Service Info

Similar tensioner pulley design

Differentiating characteristics

Photo 1: Tensioner pulley 531 0396 20 with vibration damper 533 0039 10

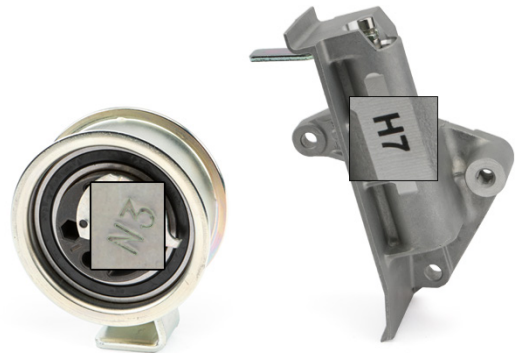
For the vehicles listed here, always be sure to observe the specified tensioner pulley and vibration damper combination.

Tensioner pulleys and vibration dampers are perfectly matched to one another and only the right combination guarantees the smoothest possible engine timing.

A mixed configuration can lead to increased wear or even failure of individual timing system components.

Part No. Tensioner	Eccentric ID	Color Eccentric	Part No. Damper	Damper ID
531 0396 20	N3	silver	533 0039 10	H7
531 0436 20	N2	black	533 0035 10	H4
